Separate shipment of batteries for GL Series

Affected products: GL22, GL24, GL32, GL34

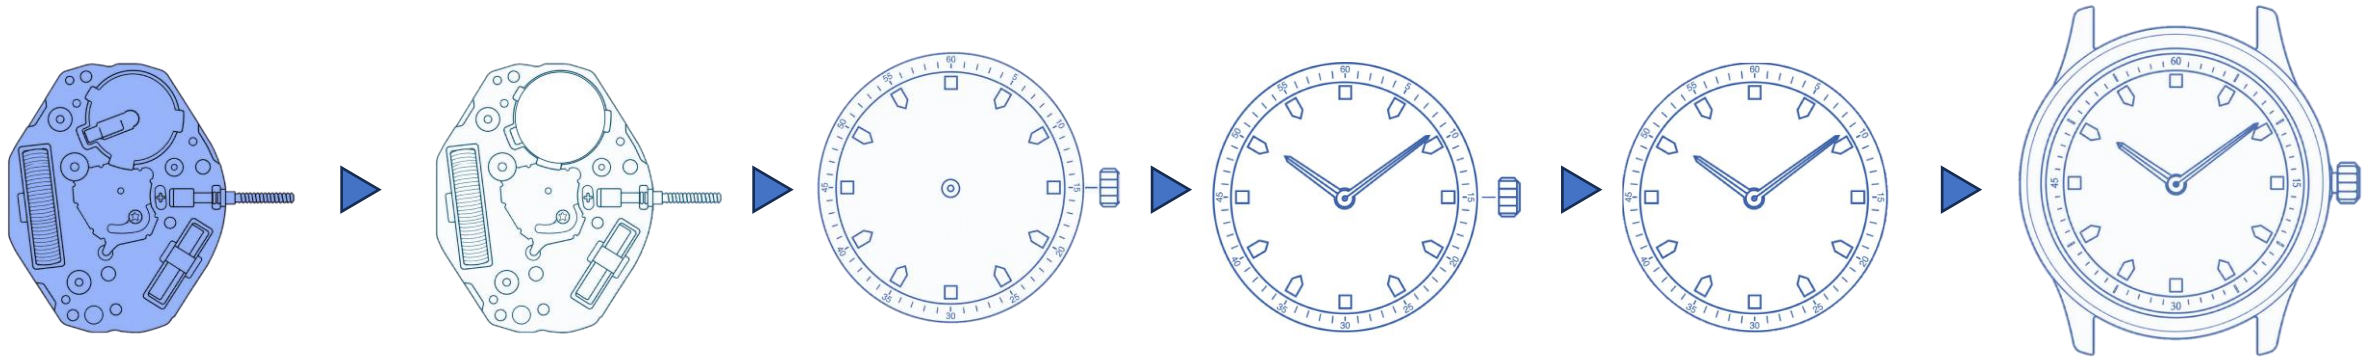
As batteries are now shipped separately, please follow the procedure below to use the product.

Recommended process of hand setting： Install the battery and set the hands after pulling the stem

Insert the stem-> Pull the stem-> Install the battery-> Attach the dial-> Set the hands-> Remove the stem-> Case up the movement

Caution) Hands may become misaligned if the stem is not pulled before hands setting.
